SUBJECT: ISSUANCE OF AMENDMENTS (TAC NOS. 73109 AND 73110)

The amendments revise the TS for DCPP to change the diesel generator (DG) allowed outage time (AOT) from 72 hours to 7 days. Prior to installation of the sixth DG, this change would apply only to the swing diesel generator (DG 1-3) for performance of preplanned preventive maintenance. After the sixth DG is installed and operational (scheduled for December 1991), the 7-day AOT would apply to all DGs.

SAFETY EVALUATION BY THE OFFICE OF NUCLEAR REACTOR REGULATION  
RELATED TO AMENDMENT NO. 44 TO FACILITY OPERATING LICENSE NO. DPR-80  
AND AMENDMENT NO. 43 TO FACILITY OPERATING LICENSE NO. DPR-82  
PACIFIC GAS AND ELECTRIC COMPANY  
DIABLO CANYON NUCLEAR POWER PLANT, UNIT NOS. 1 AND 2  
DOCKET NO. 50-275 AND 50-323

**A REVIEW OF THE DIABLO CANYON POWER PLANT  
DIESEL GENERATOR ALLOWED OUTAGE TIME STUDY**

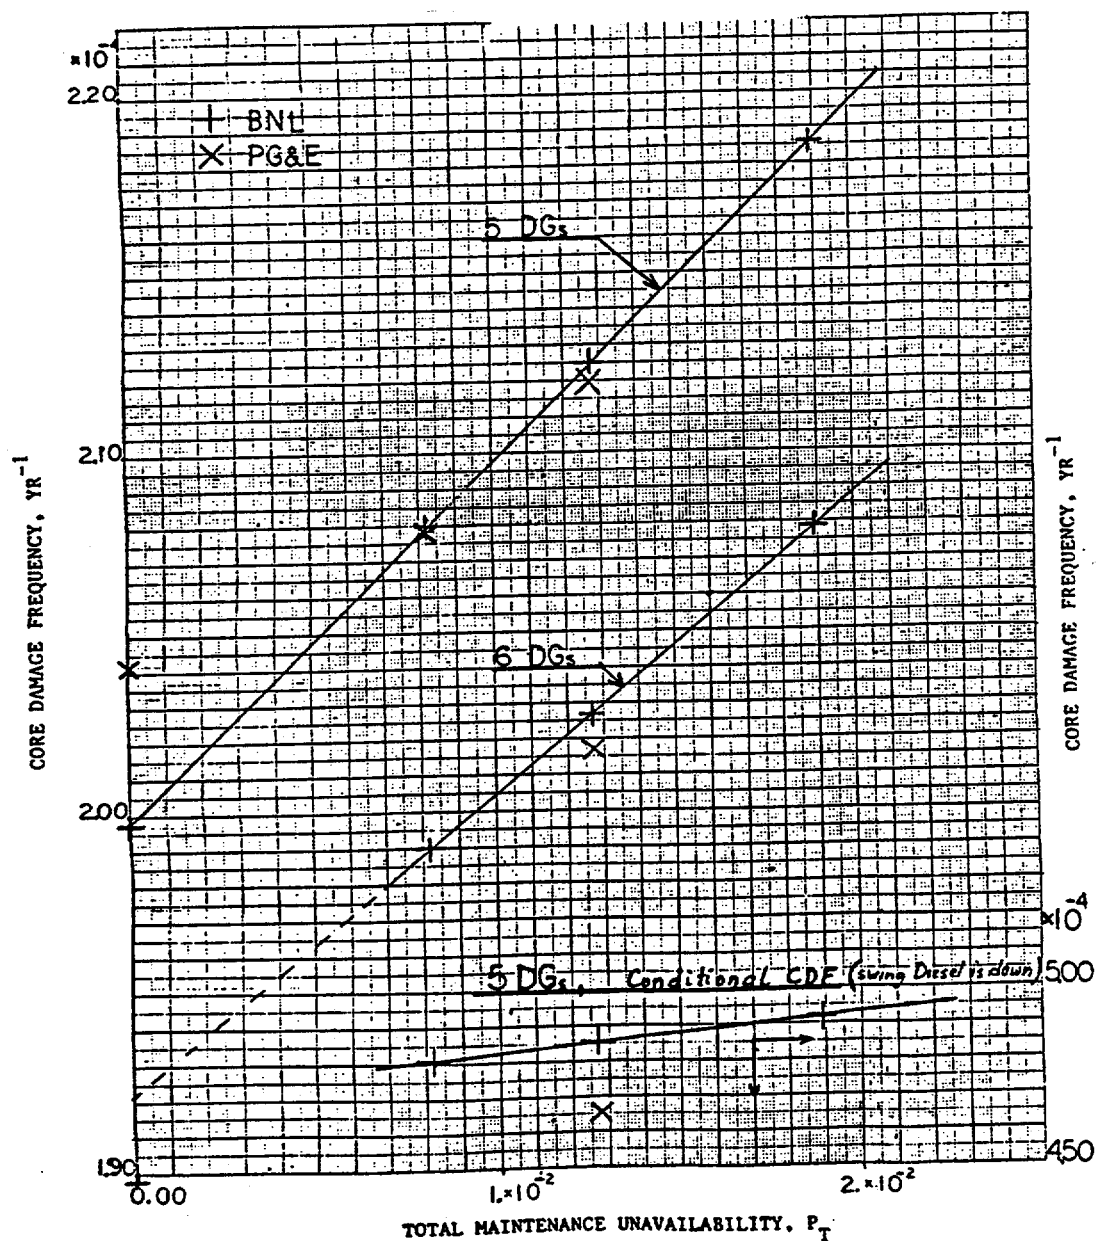
Figure 3.1 shows the core damage frequency as a function of the total maintenance unavailability,  $P_T$  for the 5DG and 6DG configurations. One can observe that the functional correlation between the CDF and the total maintenance unavailability can be fairly approximated by straight lines. The lines for 5DG and 6DG configurations run (almost) parallel, showing that under any reasonable AOT condition the 6DG configuration always provides smaller risk than the 5DG configuration.

The results obtained from the above calculations are also listed in Table 3.1 along with the original PG&E data. The conditional core damage frequency if the swing diesel is down for a year (5DG configuration) is also plotted as a function of the total maintenance unavailability,  $P_T$ , at the bottom part of Figure 3.1. The curve reflects a strong linear dependency.

- The risk reduction effect of adding the sixth DG is greater than the effect of changing to a seven day AOT. This is demonstrated by Figure 3.1, which shows that the CDF curve for the 6DG configuration always runs below and almost parallel with the CDF curve for 5 DG configuration.
- The effect on risk of changing from a three day to a seven day AOT is insignificant, on the order of 2 to 3%. (The curves in Figure 3.1 provide practical tools to evaluate risk changes for any combinations of diesel maintenance duration and frequency values.)
- The increase of the risk associated with a seven day AOT over a three day AOT performing scheduled maintenance on the swing diesel is also insignificant; less than 2.8%. The risk ratios determined by PG&E for this case are in agreement with those obtained by BNL for both 5DG and 6DG configurations.
